# TOWN OF CHAPEL HILL

COMMUNITY DESIGN COMMISSION

January 22, 2019 - Minor Alteration Request

## HILLSTONE CHAPEL HILL

## PROPOSED SITE PLAN

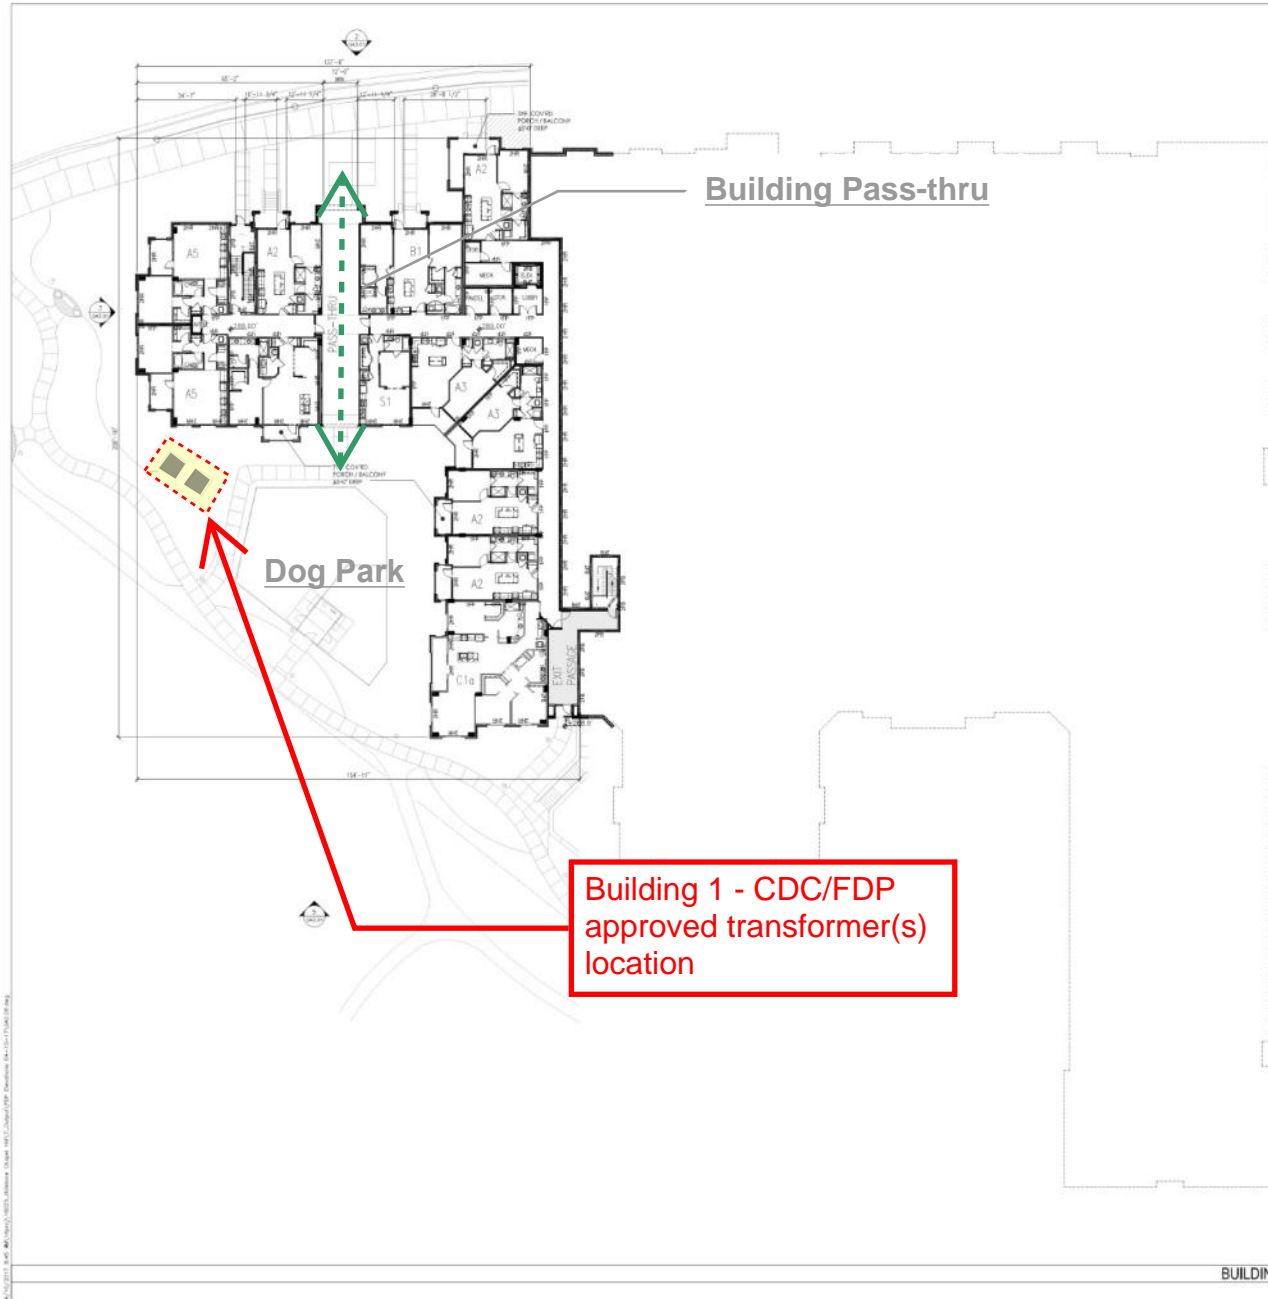
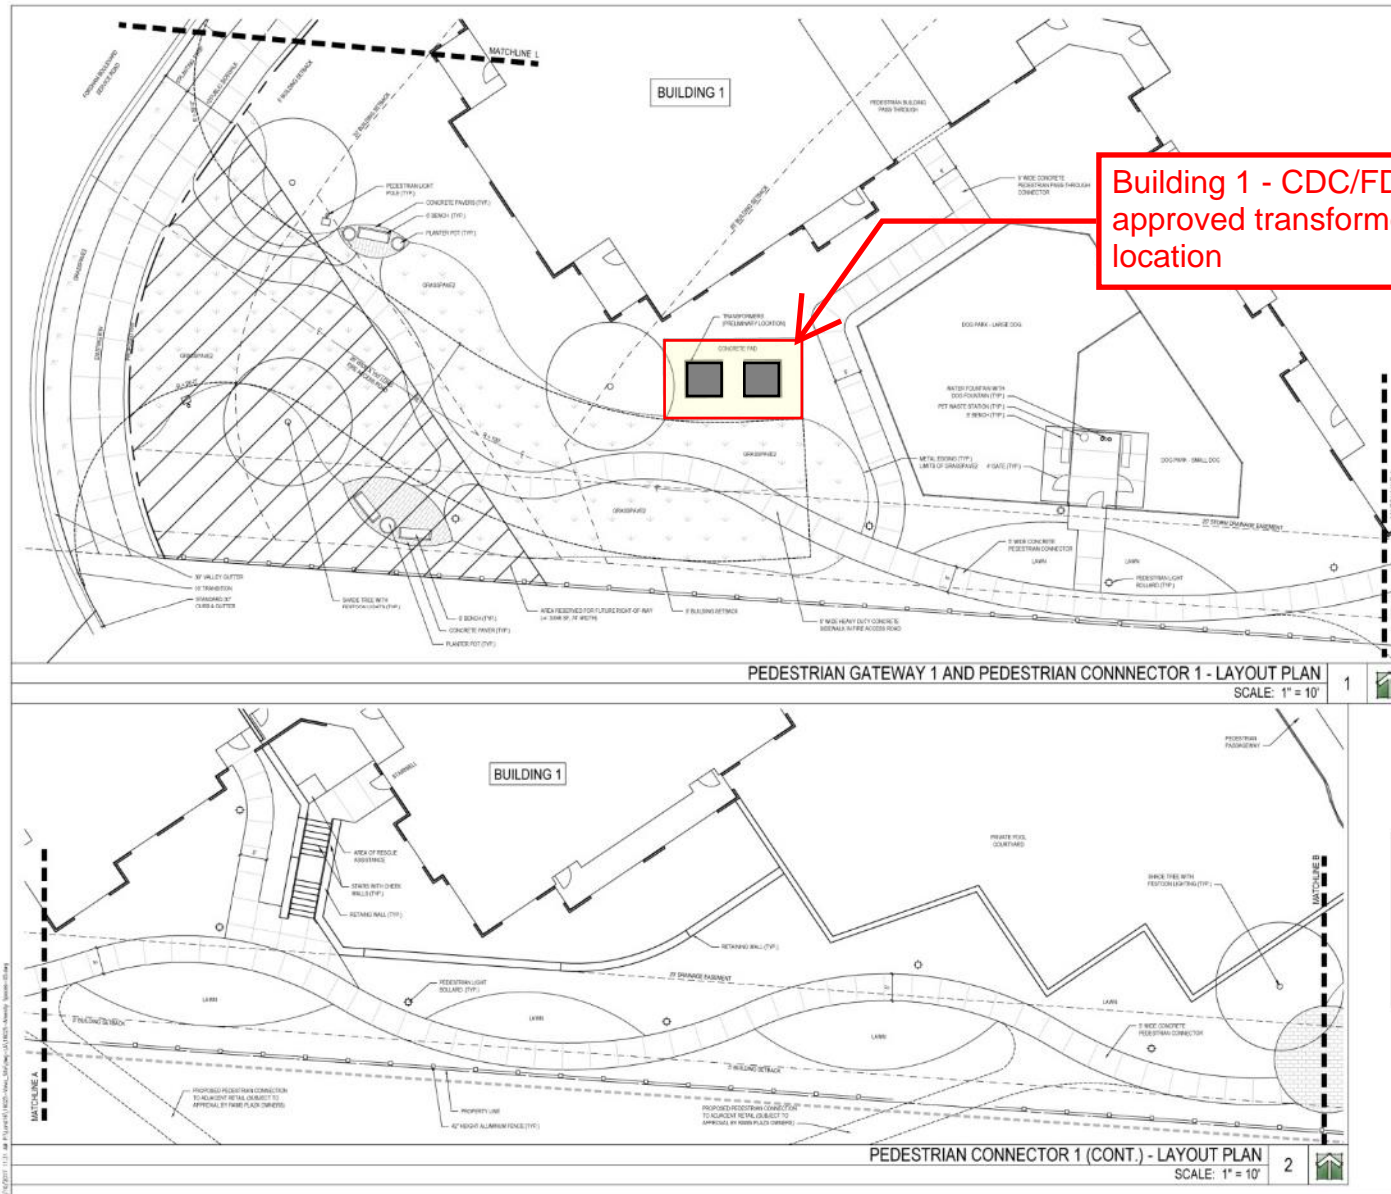
The original Building 1 design called for (2) transformers per the estimated electrical loads developed by the Engineer of Record for the project. Duke Energy is responsible for the final design of the site electrical service, which was not completed until AFTER construction began. The final Duke Energy Design requires (4) transformers which will require a larger pad footprint.

Building 1 - CDC/FDP  
approved transformer(s)  
location

Building 1 - CDC/FDP  
approved transformer(s)  
location

Locate the (4) transformers in the previously approved locations. This thereby maintains a location away from street views immediately adjacent to the site, yet still accessible to Duke Energy for maintenance.

## BEFORE - AFTER LANDSCAPE ADJUSTMENTS

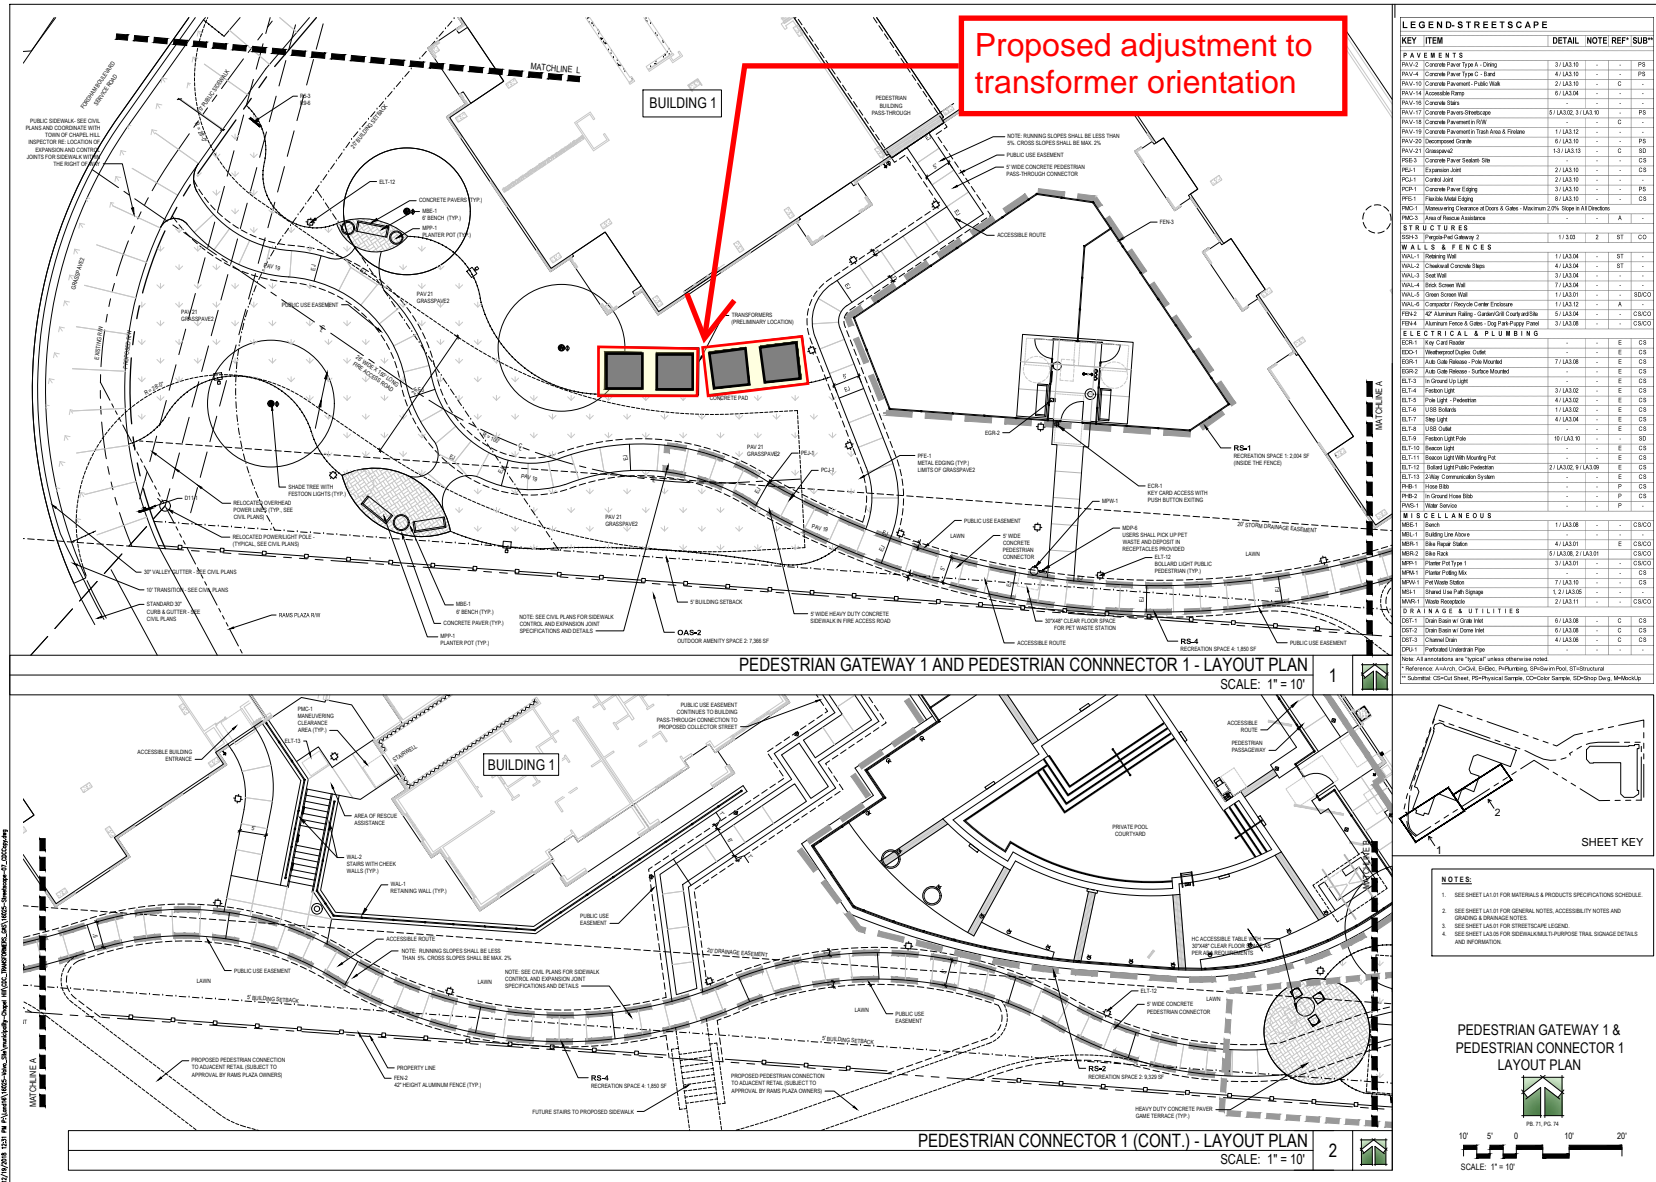
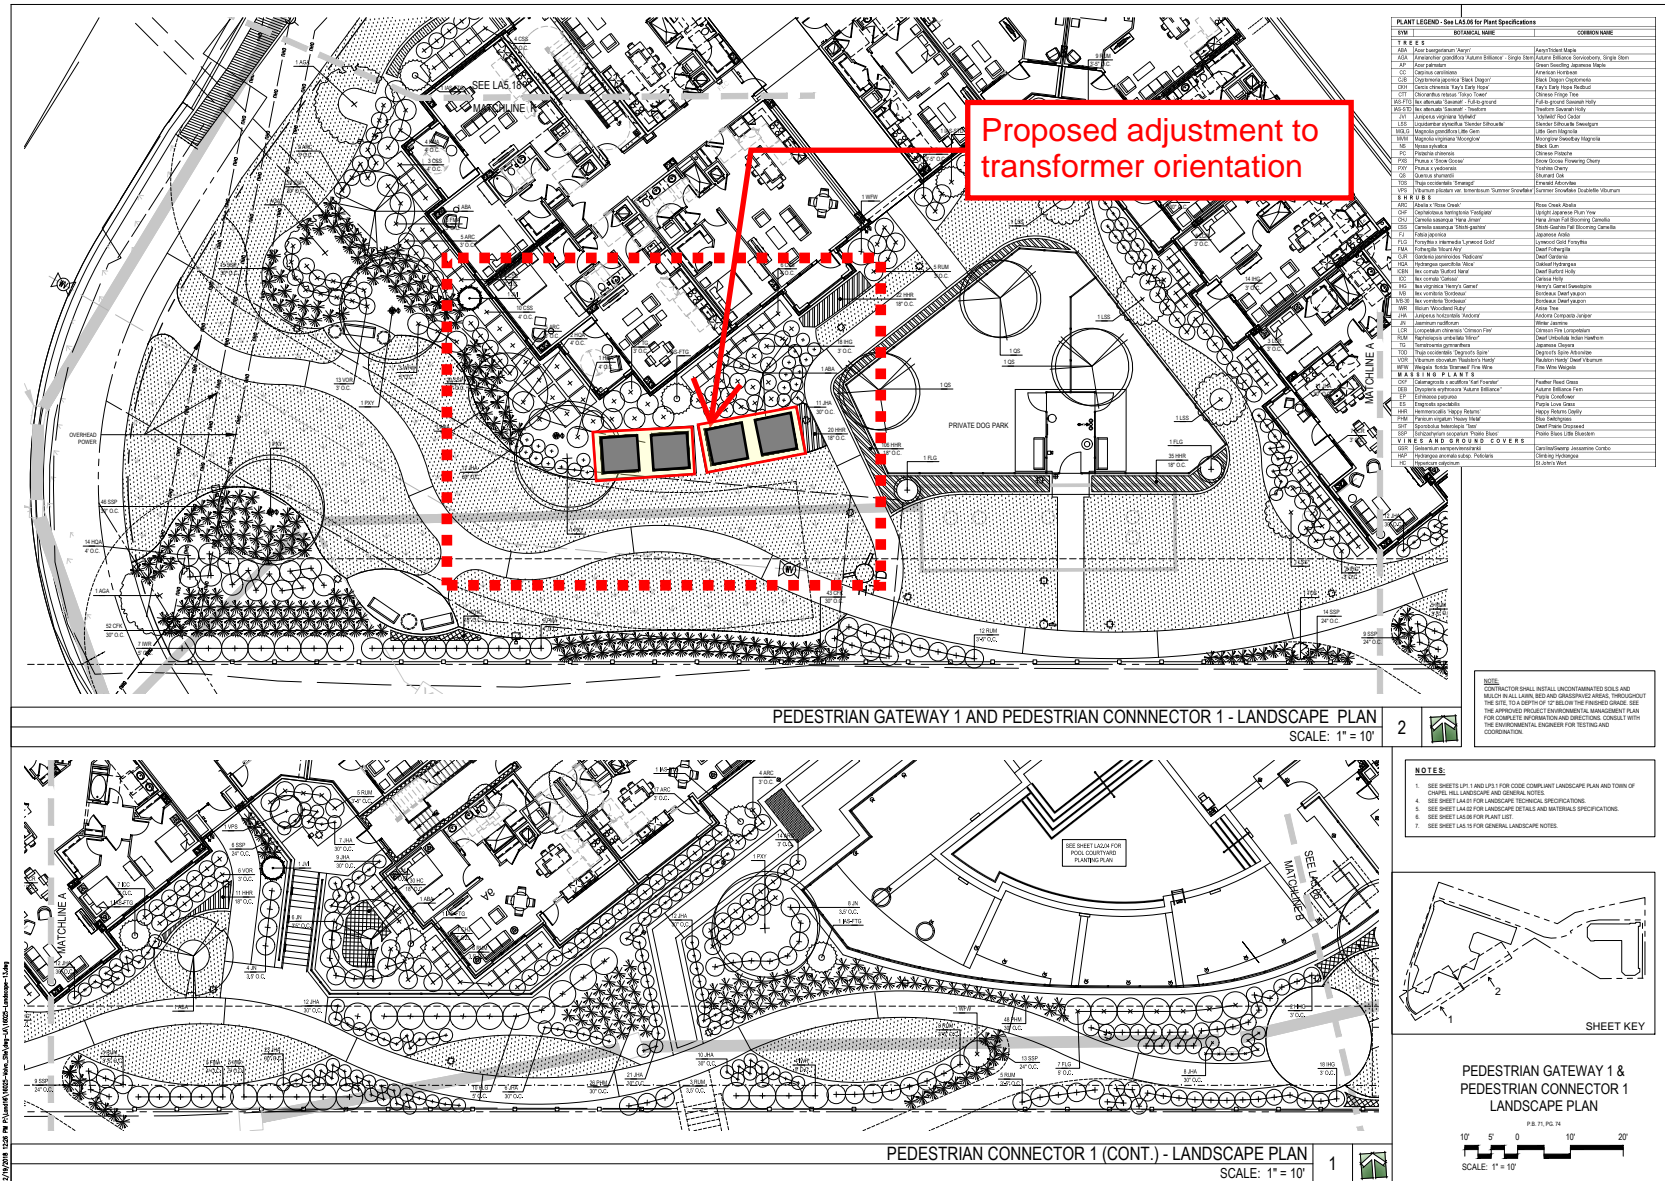
**PROPOSED MODIFICATION TO TRANSFORMER LAYOUT**

**PROPOSED ADJUSTMENT TO LANDSCAPE SCREENING SURROUND TRANSFORMERS**
